COMMITTEE DATE: 08/11/2017

APPLICATION No. **17/01850/MJR** APPLICATION DATE: 04/08/2017

APPLICANT: Board of Trustees of the Museum of Military Medicine
LOCATION: LAND OFF HEMINGWAY ROAD, ATLANTIC WHARF
PROPOSAL: CONSTRUCTION OF A MUSEUM, WHICH INCLUDES A
CAFE, EXHIBITION ROOMS, COLLECTION STORES AND
OFFICE SPACE AT LAND OFF HEMINGWAY ROAD,
CARDIFF BAY

Drawing Title
Ground Floor Plan

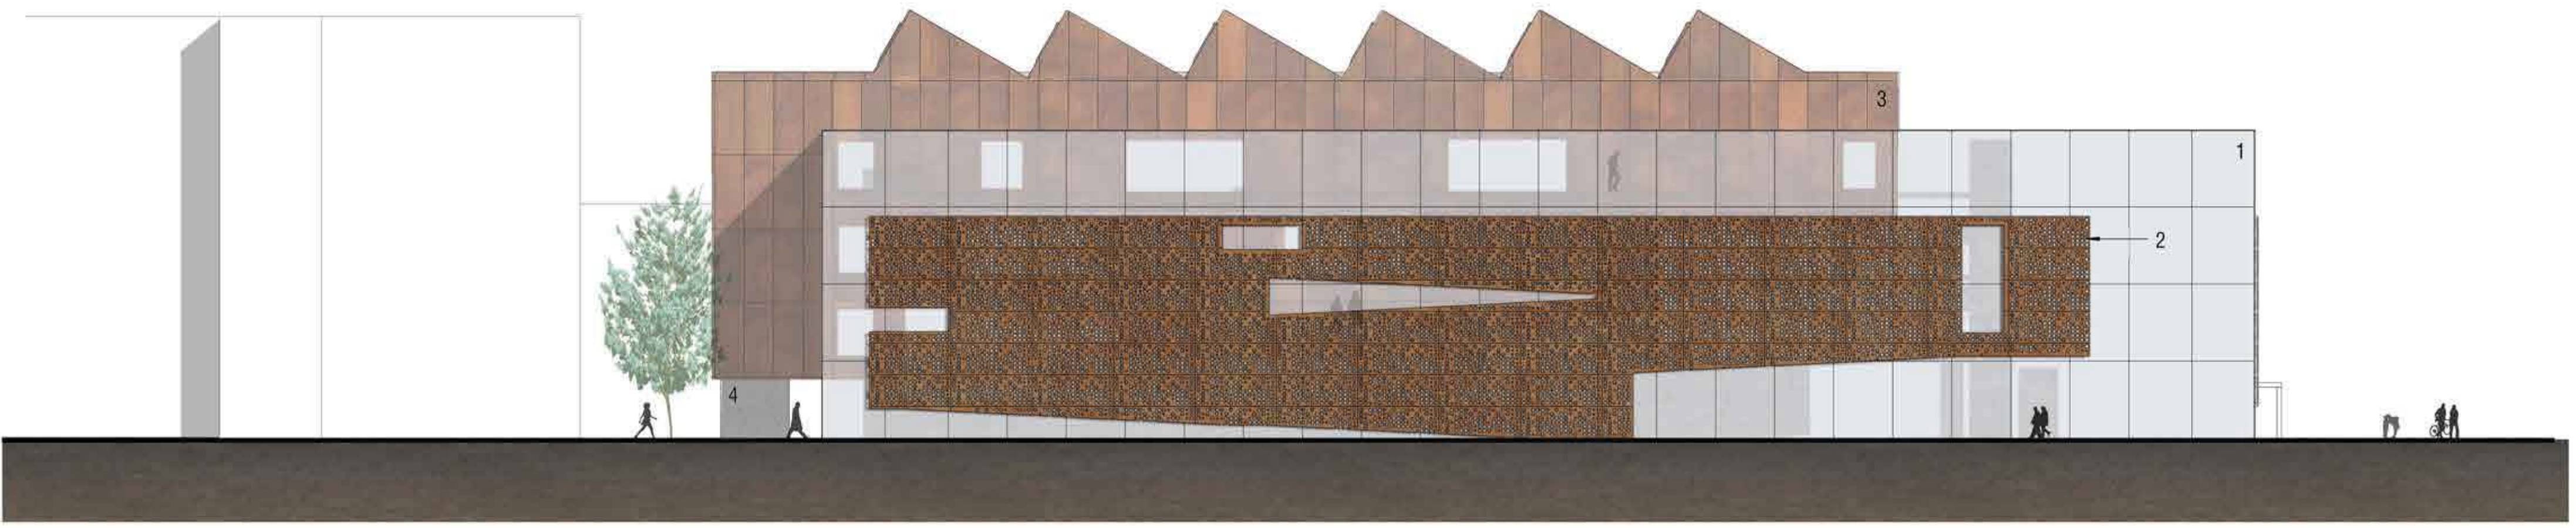
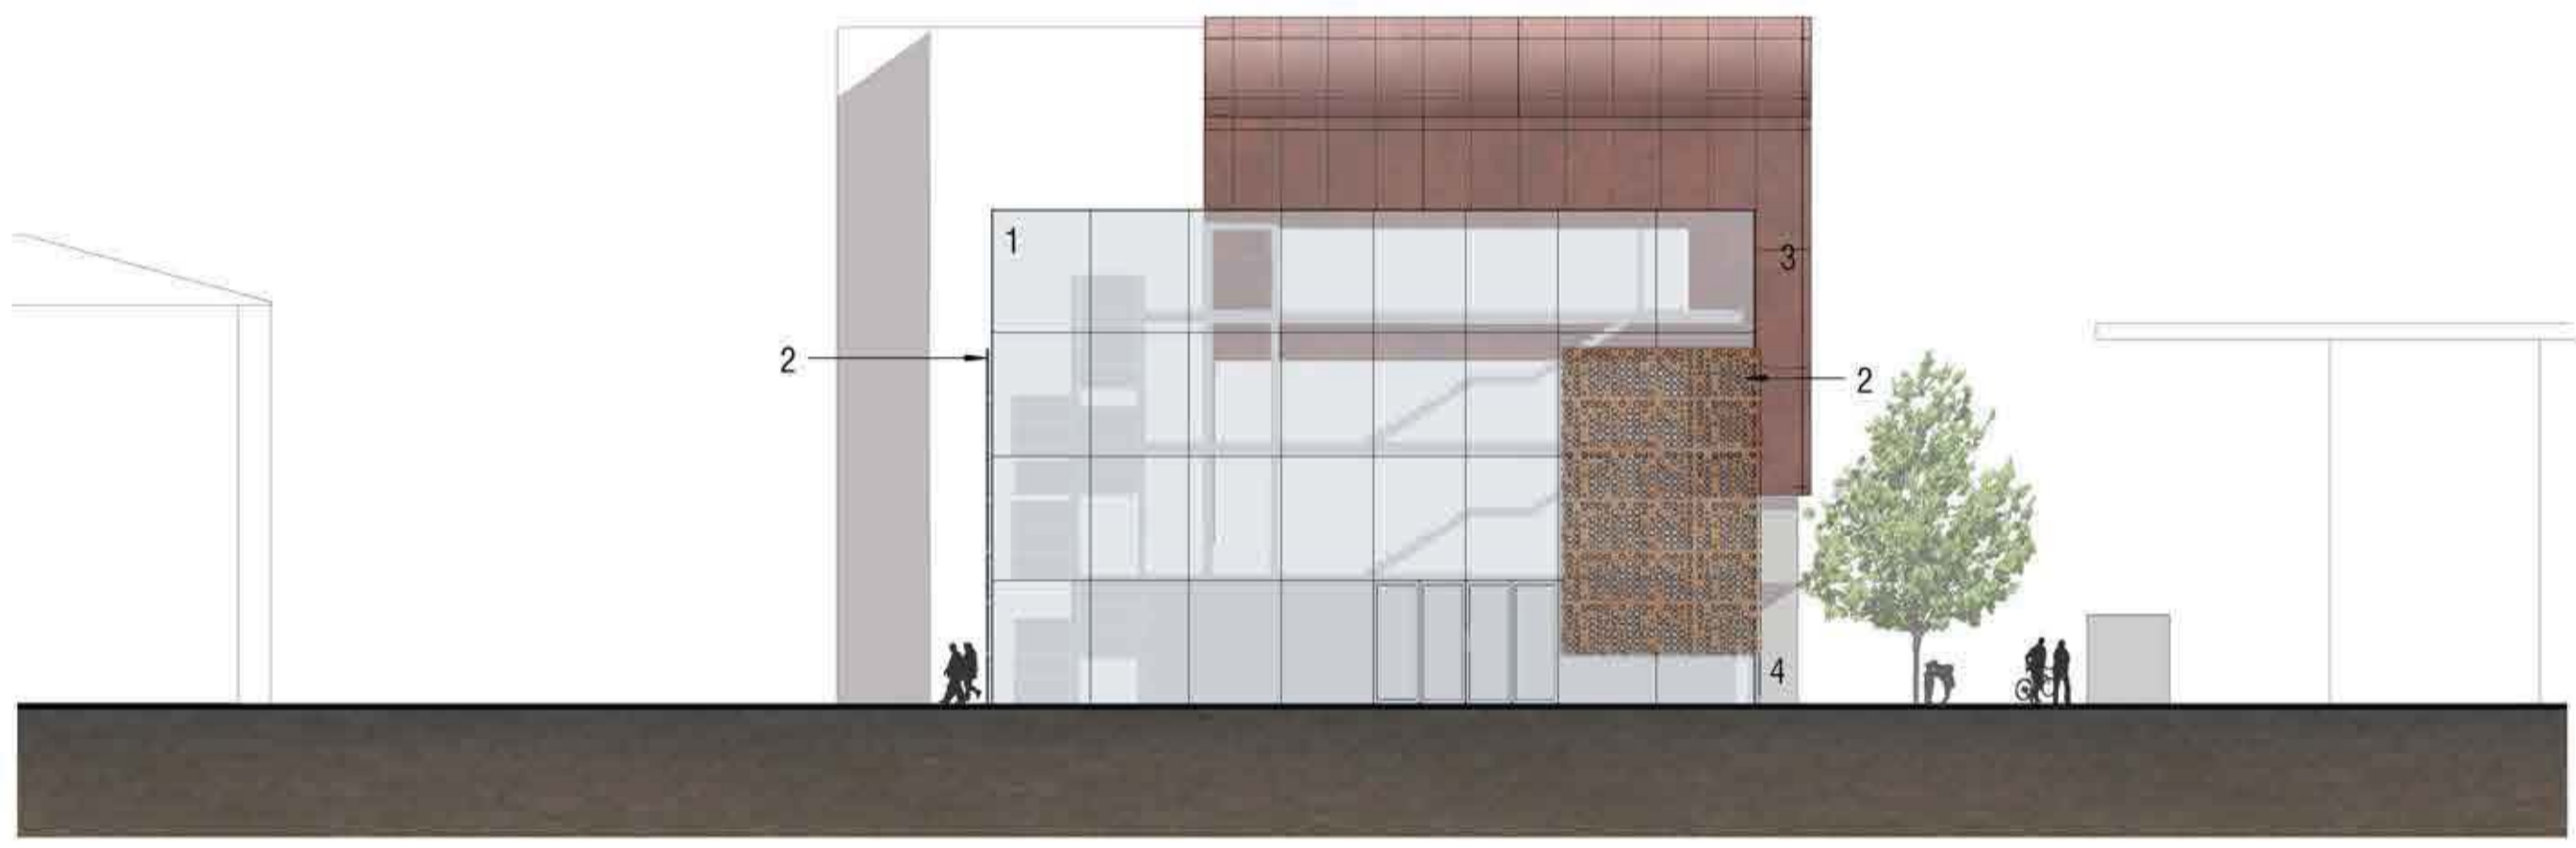
Plan 16659 TP(10)100 Rev 4 shows a layby to the north of the proposed museum on Hemingway Road. This is not shown on any of the other plans being presented as part of the proposal. The layby is not considered to be part of the design layout, as this could encourage inappropriate parking and waiting activity.
